**ZONING AMENDMENT
& SUBDIVISION STAFF REPORT****Date: July 7, 2016**

<u>APPLICANT NAME</u>	Ben Cummings-Cummings Architecture
<u>SUBDIVISION NAME</u>	CEA Properties Subdivision
<u>LOCATION</u>	1151 Dauphin Street (Southwest corner of Dauphin Street and Oakland Terrace)
<u>CITY COUNCIL DISTRICT</u>	District 2
<u>PRESENT ZONING</u>	R-1, Single-Family Residential District and B-1, Buffer Business District
<u>PROPOSED ZONING</u>	B-1, Buffer Business District
<u>AREA OF PROPERTY</u>	3 Lots / 1.3 ± Acres
<u>CONTEMPLATED USE</u>	Subdivision approval to create 3 lots, and Zoning approval to rezone the site from R-1, Single-Family Residential District, and B-1, Buffer Business District, to B-1, Buffer Business District to eliminate split zoning. It should be noted, however, that any use permitted in the proposed district would be allowed at this location if the zoning is changed. Furthermore, the Planning Commission may consider zoning classifications other than that sought by the applicant for this property.

APPLICATION NUMBER 18 DATE July 7, 2016
APPLICANT CEA Properties Subdivision
REQUEST Subdivision, Rezoning from B-1 and R-1 to B-1

DETAIL SITE PLAN

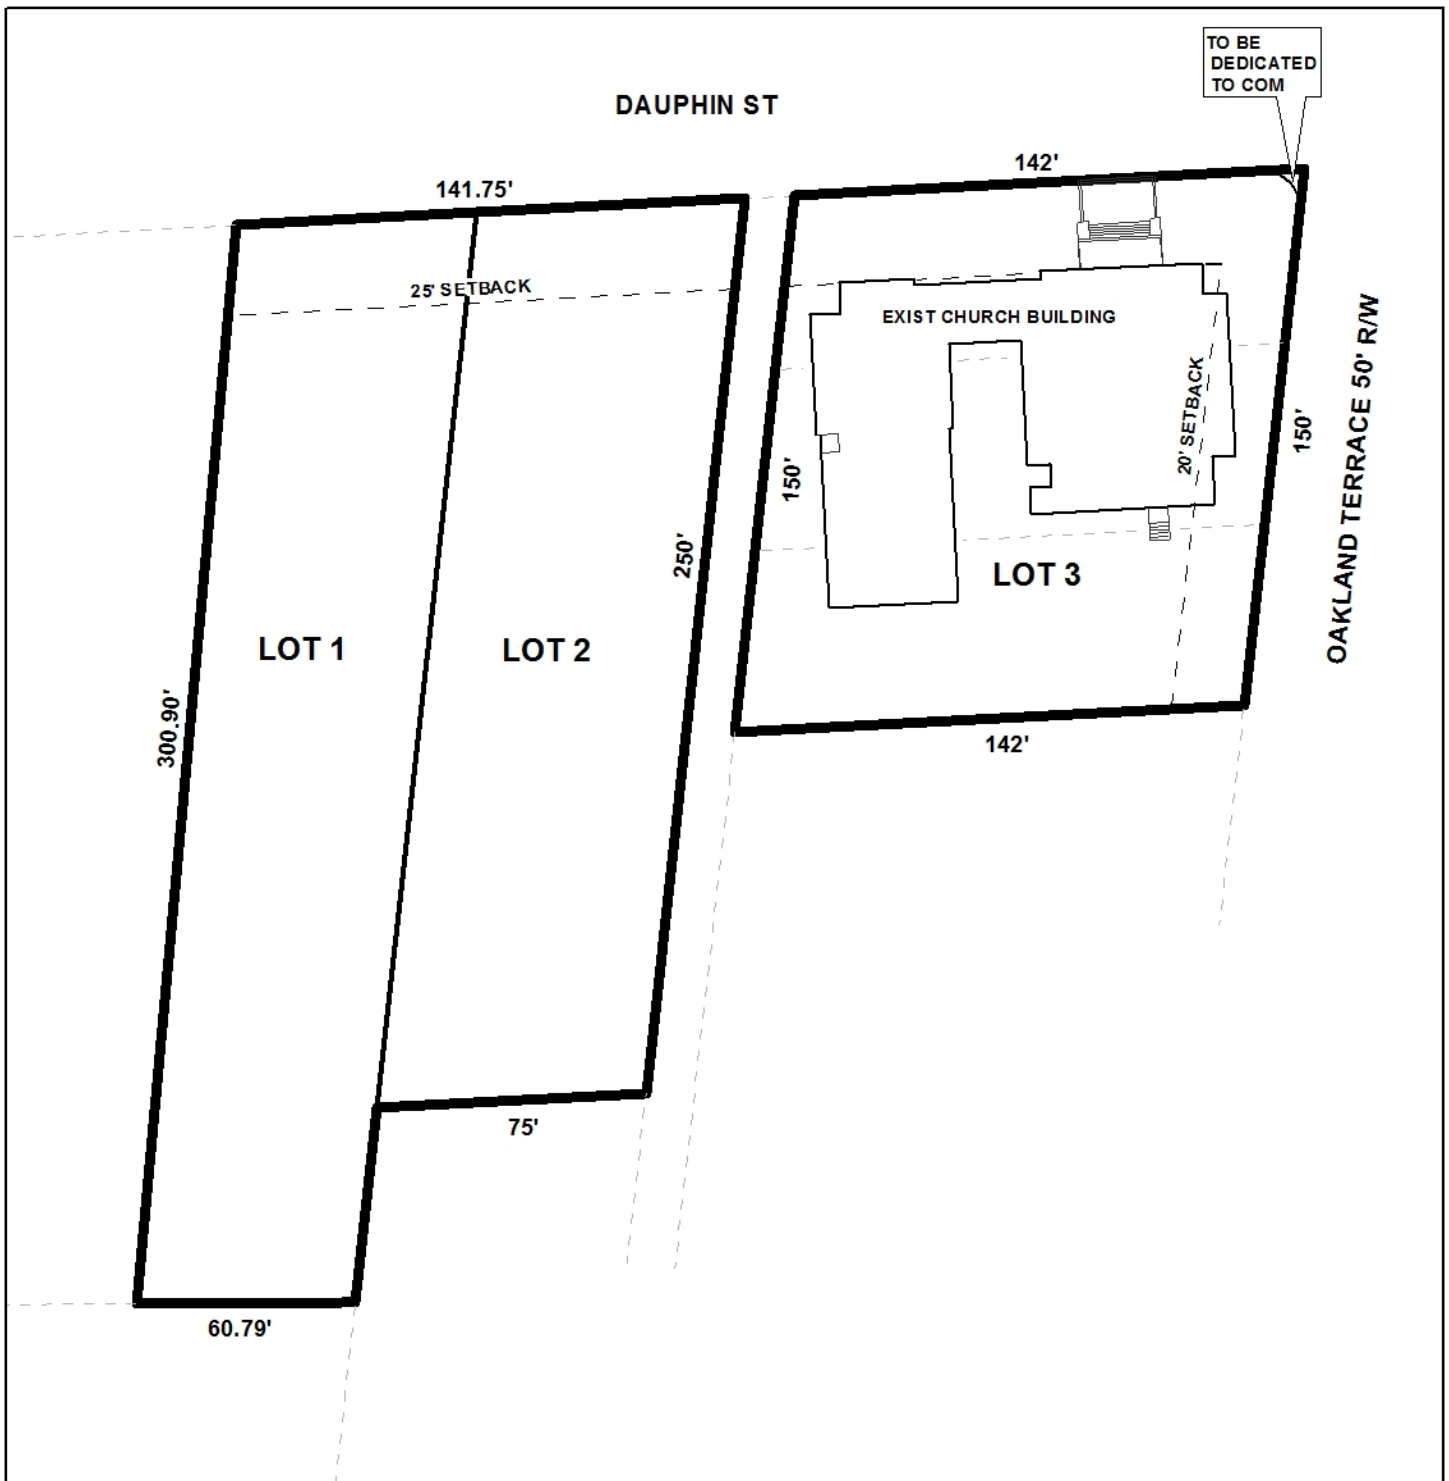
The preliminary plat depicts a corner-radius dedication for Lot 3, at the intersection of Dauphin Street and Oakland Terrace. This dedication should be retained on the Final Plat, if approved.

The 25-foot minimum building setback is depicted along Dauphin Street, however, a 20-foot setback is depicted along Oakland Terrace. If Dauphin Street is considered the fronting street for Lot 3, the Zoning Ordinance allows the side street setback to be reduced to 20 feet. A waiver of Section V.D.9. of the Subdivision Regulations to allow for the Zoning Ordinance reduced setback will be required. Additionally, as previously mentioned, due to Dauphin Street's status as a proposed major street, the minimum building setback along Dauphin Street should be increased to 45 feet.

- 1) Revision of the plat to depict the minimum building setback line along Dauphin Street as 45-feet, to accommodate the proposed future right-of-way width of Dauphin Street, a proposed Major Street;
- 2) Placement of a note on the plat stating that Lots 1 and 2 are limited to one shared curb-cut, that Lot 3 is limited to its existing curb-cut to Oakland Terrace, and that any change to the size, design or location of curb-cuts is to be approved by Traffic Engineering, and conform to AASHTO standards;
- 3) Provision of the corner radius dedication at the Dauphin Street/Oakland Terrace intersection, as depicted on the preliminary plat;
